Re: PETITION 1350 - EIP Investment LLC Petition for a Declaratory Ruling, pursuant to Connecticut General Statutes §4-176 and §16-50k, for the Proposed Construction, Maintenance and Operation of a 19.98-megawatt Combined Heat and Power Fuel Cell Facility and Associated Equipment to be Located Within Building 107 on the Corner of Curtis Street and the Pan Am Southern, LLC Railroad Tracks at the Stanley Black & Decker Campus, 480 Myrtle Street, New Britain, Connecticut

Enclosed please find the original and fifteen (15) copies of EIP Investment LLC's responses to the Siting Council's First Set of Interrogatories dated October 5, 2018 in connection with the above-referenced petition. Responses to Interrogatories 11 and 36 will be filed separately.

Figure 1. PureCell Model 400 Subsystems

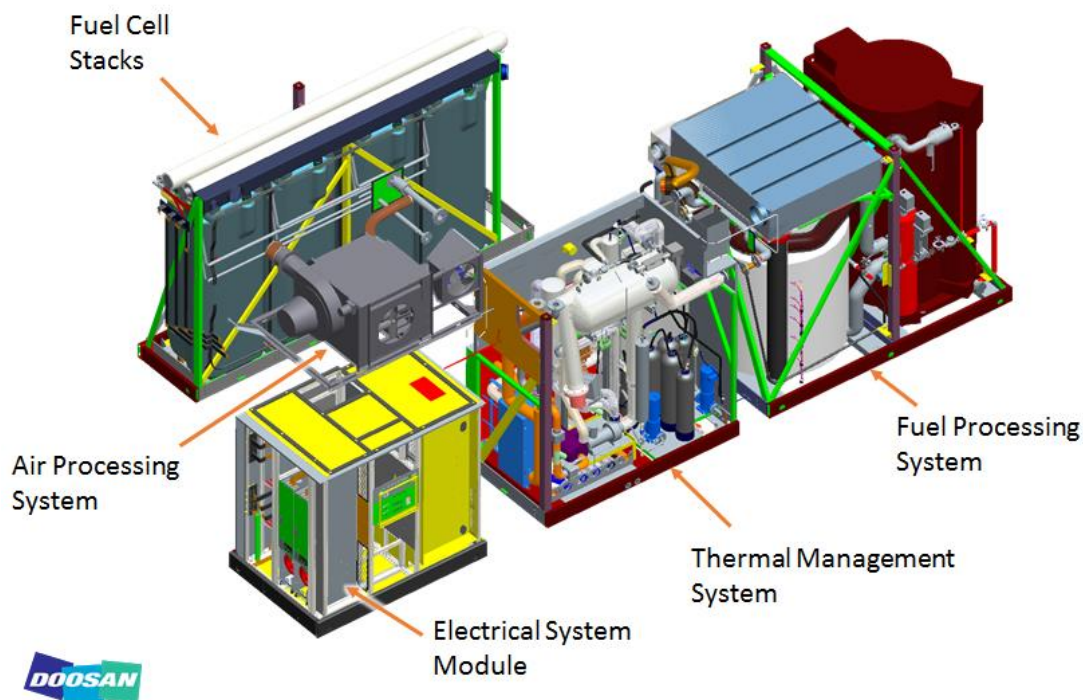
Q-CSC-1-34: Natural gas has sulfur dioxide injected as an odorant. Please submit a desulfurization plan narrative for the proposed fuel cell facility containing the following information:

- a) Chemical reaction overview concerning what substances are produced from the desulfurization process, as well as plans for their containment and transport;
- b) How much solid sulfur oxide would result from the desulfurization process, and methods and locations for containment, transport, and disposal;
- c) Whether any of these desulfurization substances are considered hazardous, and if so, plans for the containment, transport, and disposal of hazardous substances;
- d) Anticipated method of disposal for any other desulfurization substances; and
- e) Whether any gaseous substances resulting from desulfurization can be expected to vent from the fuel cells, as well as the applicable DEEP limits regarding discharge of these gasses.

The FPS converts pipeline-quality natural gas into hydrogen reformat – a hydrogen-rich gas that is delivered to the anode side of the fuel cell stacks. This module includes a condenser to recover water generated in the fuel cell reaction by condensing water vapor from the process exhaust. This eliminates the need for makeup water under most operating conditions. The recovered water is used in the steam reformation process. The main components of the FPS include the following:

The desulfurizer system removes sulfur used as an odorant in natural gas, which is a poison to the catalysts used in the fuel cell systems. Sulfur is converted to zinc-sulfide, a non-hazardous waste, within the desulfurizer and remains there until an overhaul is required, nominally after 10 years. This system will also remove small amounts of oxygen in the gas.
